4L60E-PR

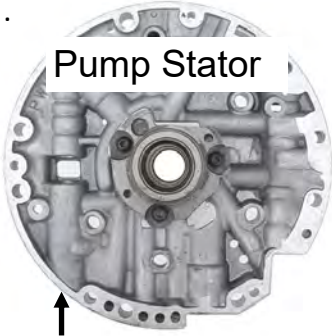
New Valve has longer lands on the outboard end.
This adds support for a worn Pump casting.

This land is purposely made under sized to provide additional lube.

Always use New Spring Seat and New Orange Bumper Spring with this New PR Valve.

Reuse Main Regulator Spring.
If using this Valve with any other TransGo Kit use the Spring provided in that Kit.
